EDMS NO.
1973010

REFERENCE
LHC-TC-EC-0012

ENGINEERING CHANGE REQUEST

Installation in IR2 of dispersion suppressor collimators (TCLD)

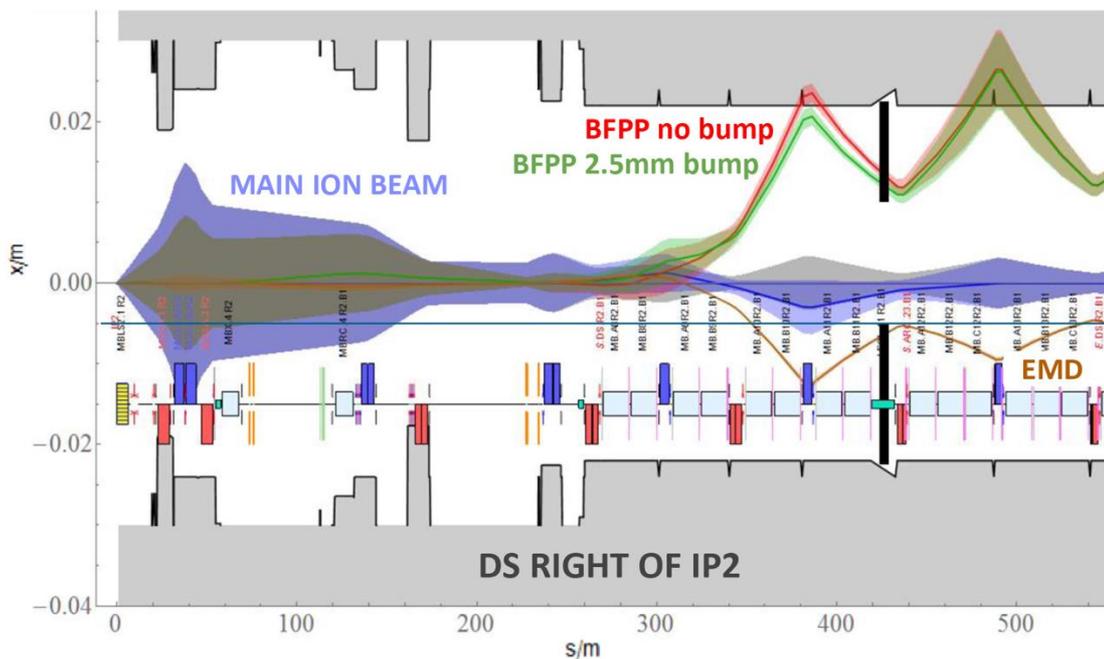
The magnets that are impacted by these losses are likely to quench at the high luminosities foreseen for HL-LHC. As alleviation, it is planned to install additional collimators (shown as black lines in Figure 1).

As can be seen in Figure 1, these secondary beams are lost very locally due to the large and sudden change of magnetic rigidity at the interaction point. After the LS2 ALICE upgrade, aiming at a peak luminosity of $6 \times 10^{27} \text{cm}^{-2} \text{s}^{-1}$ (about six times higher than the nominal one) [3], the dominant BFPP1 beam can carry about 155 W, resulting in a

Figure 6 – The assembly to be installed at the location of the IP2 connection cryostats, consisting of TCLD collimator, support, beam pipe for the other beam, and cryo-bypass. Courtesy of L. Gentini – SmarTeam number ST0676575.

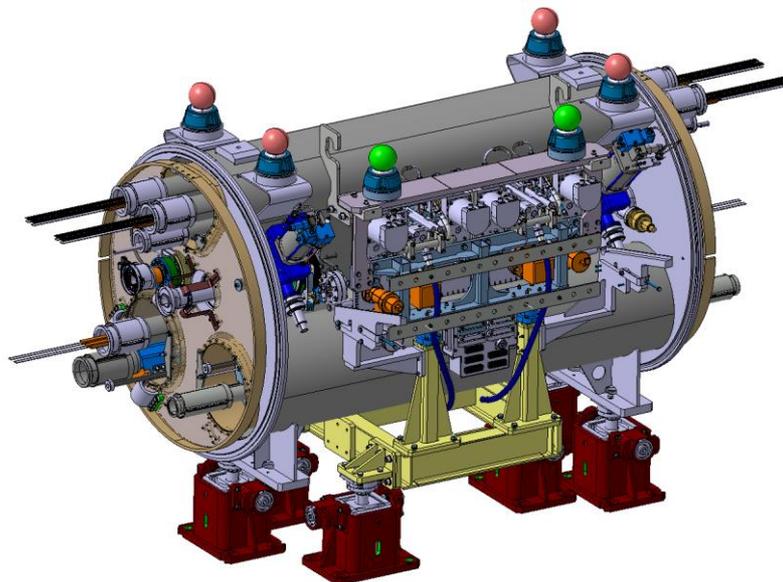
The TCLD will be integrated in a specially designed assembly, containing a beam pipe for the other beam, as well as a cryo-bypass, which is needed since the TCLD is a warm element placed between two cold ones. This assembly, which is discussed more in detail in a separate ECR, is shown in Figure 6.
